Draft Wilton Town Centre Precinct Rezoning

Draft Wilton Town Centre Precinct Rezoning

Figure 1: Comparison between Rezoning Proposal (left) and Structure Plan (right) road alignments in the south-western portion of the Town Centre Precinct with contour overlay

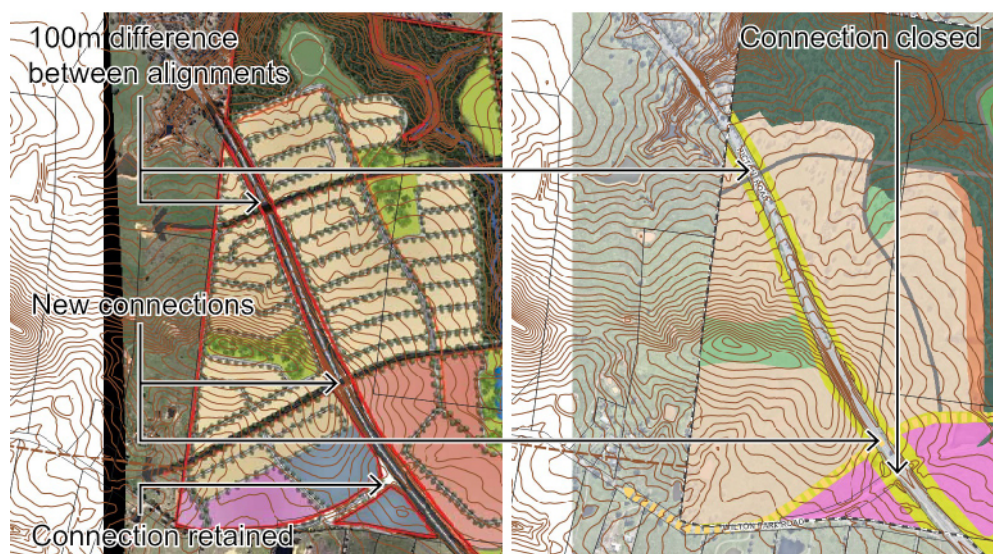
As shown in **Figure 1**, the exhibited Structure Plan and supporting DCP documents differ to the Planning Proposal specifically in terms of the alignment of future roads connecting the Town Centre to the West Wilton Precinct.

Accordingly, the Rezoning Proposal should be updated to reflect the exhibited Structure Plan, or struck from the list of exhibited documents such that it cannot be relied upon should the proponent wish to vary the Structure Plan at DA stage.

Figure 2 Part 7 Wilton Town Centre DCP application area

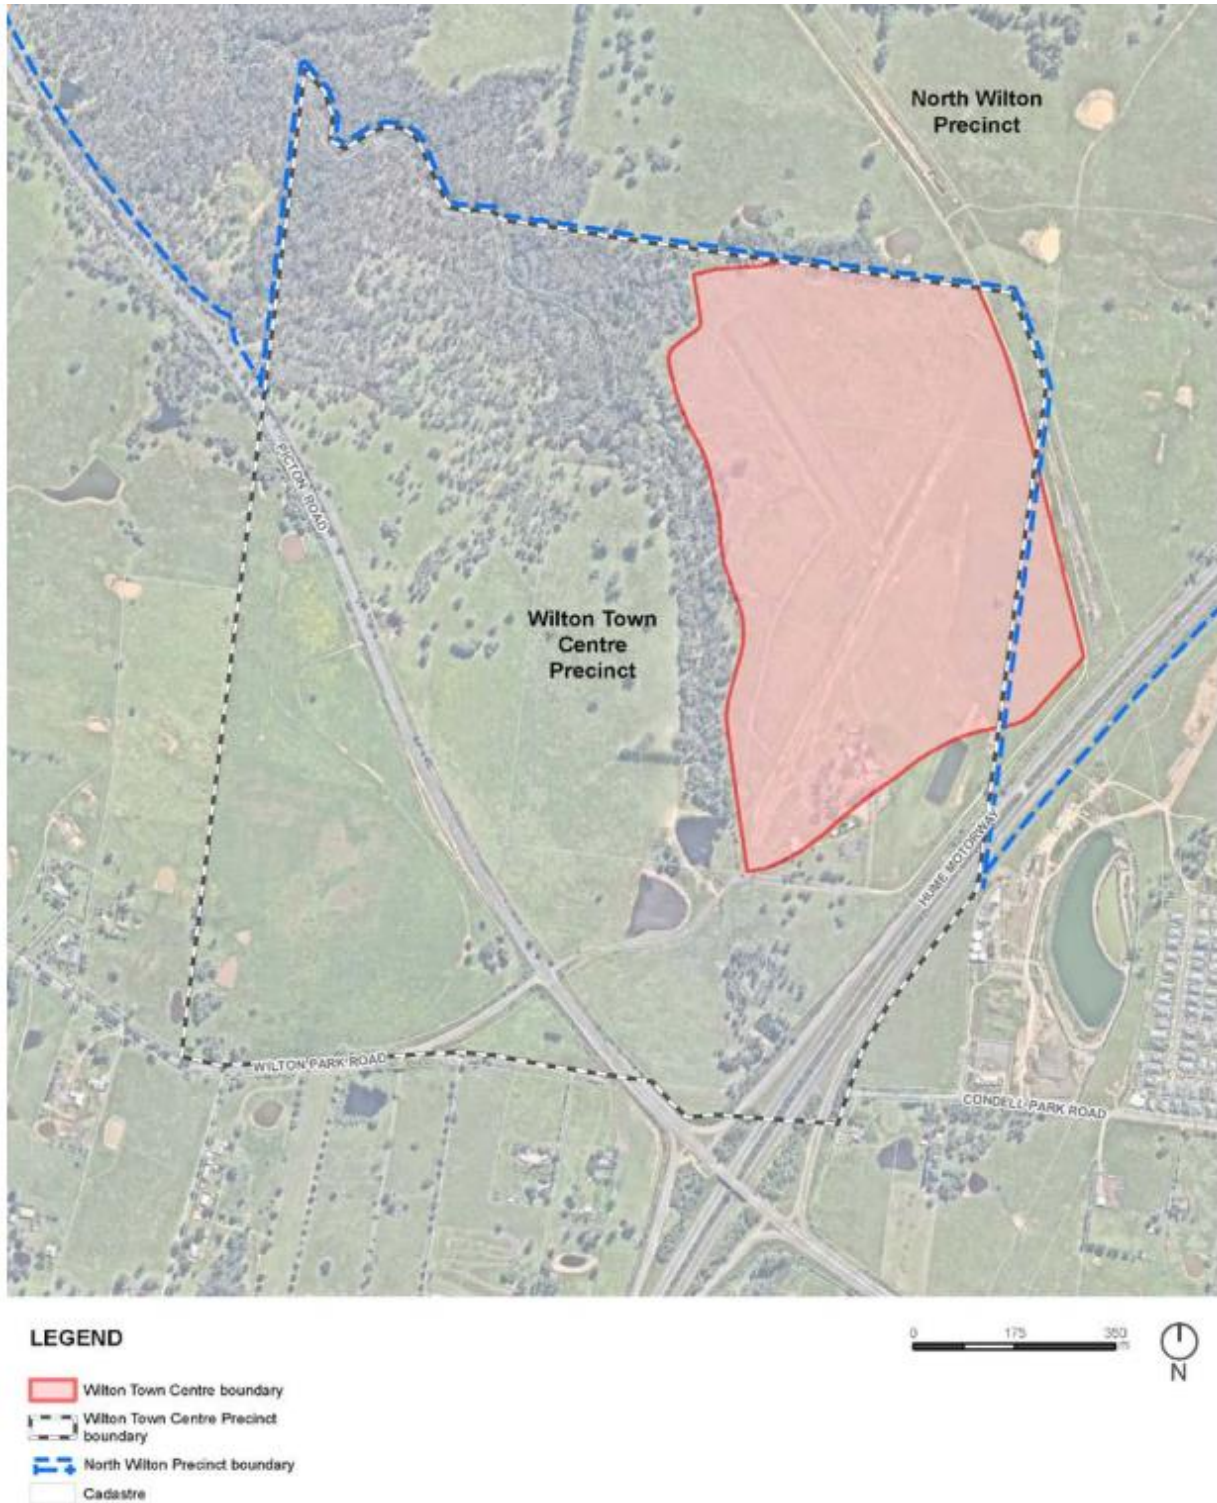
Part 7 Wilton Town Centre applies to the area between the MDRC and the north south riparian corridor and includes land within the North Wilton Precinct (see Figure 2). However, draft Part 7 of the DCP only applies to land within the Town Centre Precinct. Further clarification is needed on the application of the DCP

Figure 3: Centres Hierarchy

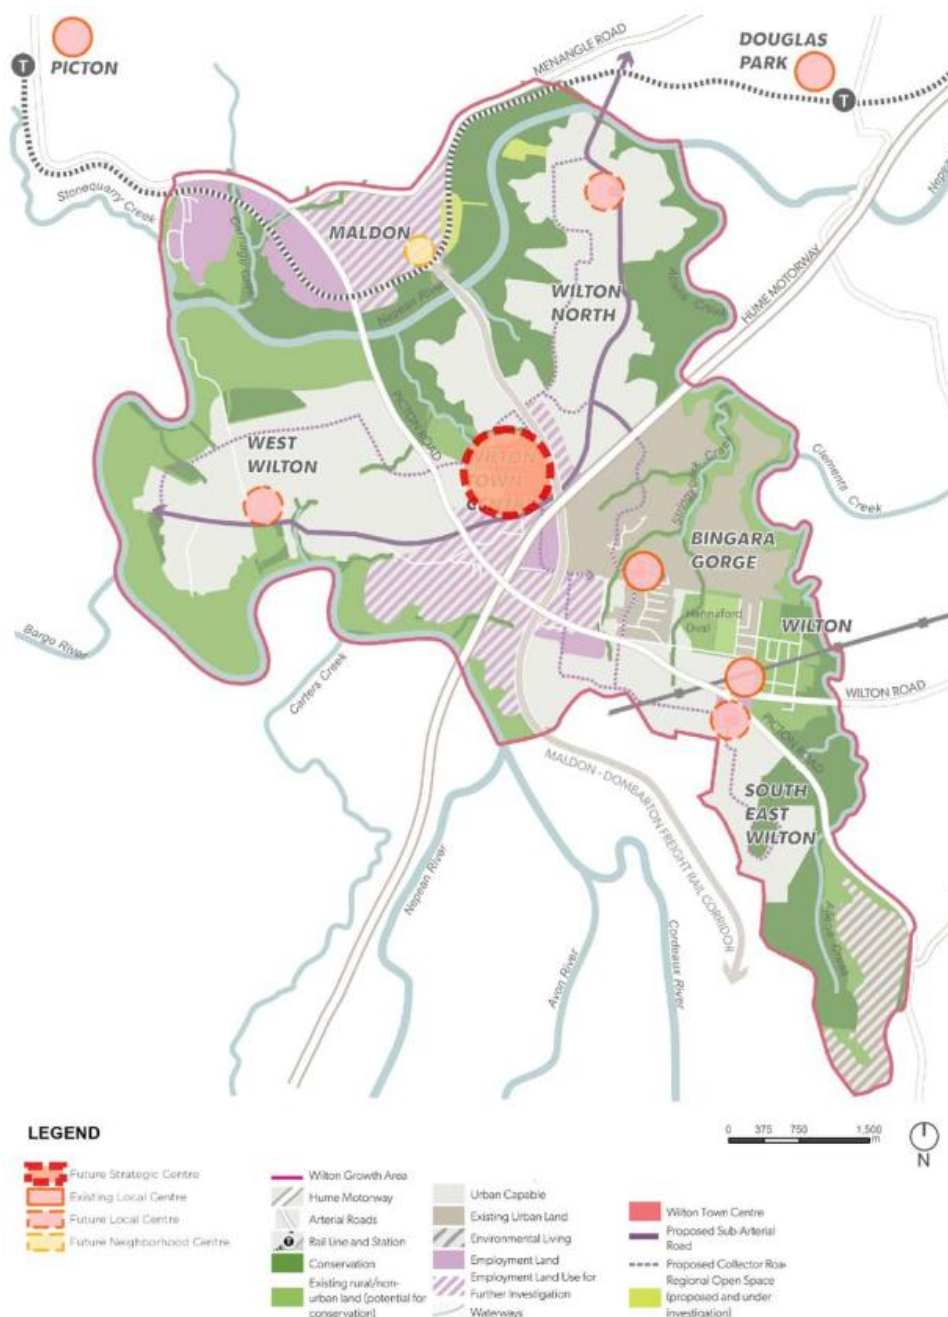
Table 2 of the Part 6 Employment DCP sets out the role and function of each of the centre types. Importantly, Table 2 indicates that a total capacity of 20,000m² of retail GFA has been identified for local centres outside of the Town Centre Retail Core. This includes the Local Centres in the north of the North Wilton Precinct, West Wilton and the South East Wilton Precinct.

However, Table 2 fails to recognise the Lakeside Hub located in the North Wilton Precinct. Situated on the proposed Lake, the Lakeside Hub forms a critical component of the North Wilton Precinct, and its vision to create a unique community and recreation focal point. The Lakeside Hub is identified in the adopted North Wilton Structure Plan (refer to Figure 4), which also identifies the 5,000m² retail GFA limit.

1. Amend Table 2 of the draft Part 6 Employment DCP that recognises the Lakeside Hub and its role and function as a 'centre'.
